S455 MODIFICATION NOTES

NEW DUAL OCCUPANCY (TORRENS)

STATUS:S4.55 MODIFICATION

STREET NAME: 7 PEPPER TREE WAY, TAREE

SITE PLAN

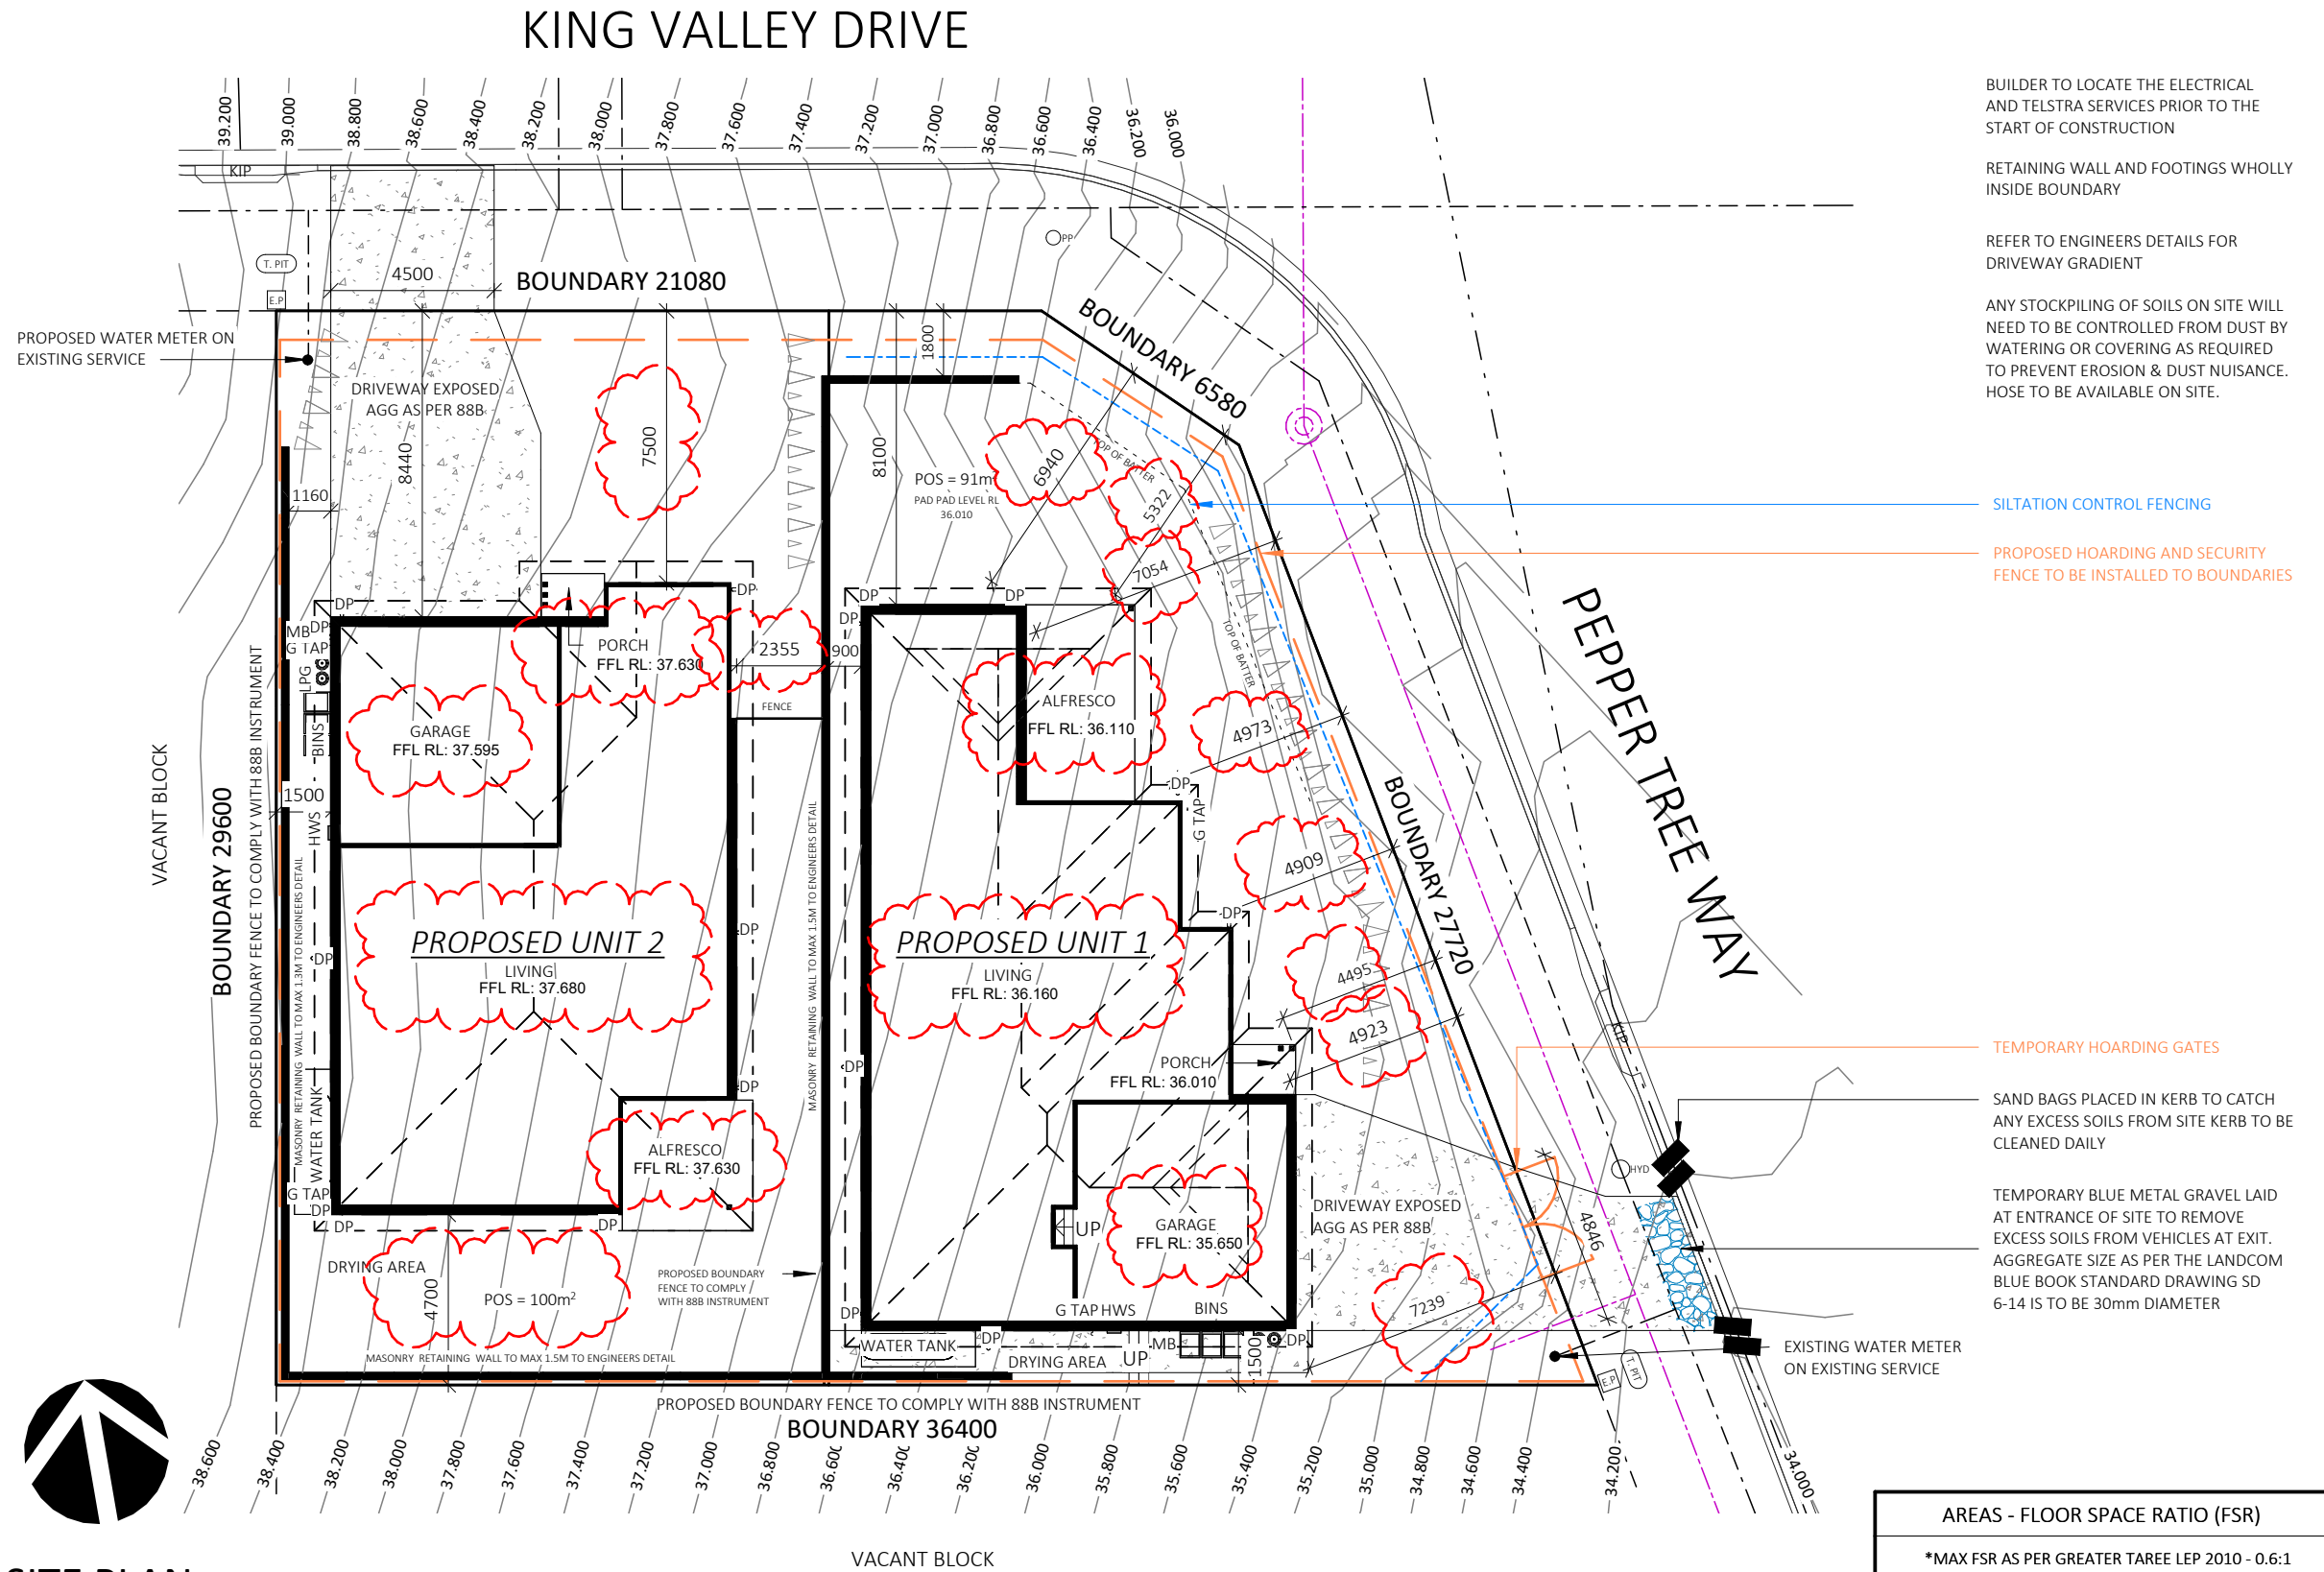
- SUB-DIVISION TYPE: TORRENS
- POSITION OF U1 AND U2 ON SITE
- U1 CLOSER TO PEPPER TREE
- U2 CLOSER TO KING VALLEY DRIVE
- CLADDING TO U1 FACADE CHANGE
- LEVELS OF U1 AND U2 ON SITE
- U1 LOWERED
- U2 RAISED
